In the Drawings:

REMARKS

Fig. 5

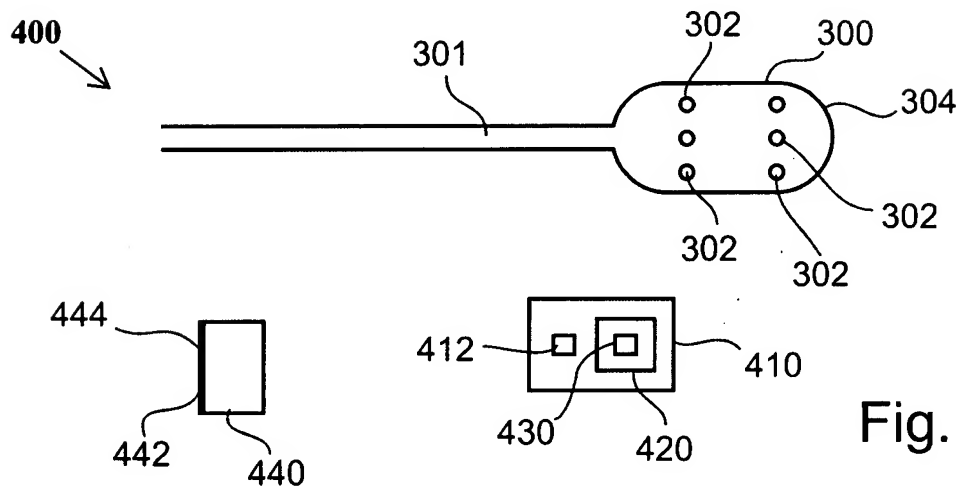
The Examiner has objected to the drawings as failing to comply with 37 CFR 1.84(p)(5) because they do not include reference signs for "System 400" mentioned in the description. A reference sign for System 400 has been added to Figure 5, a corrected copy of which is submitted herewith.
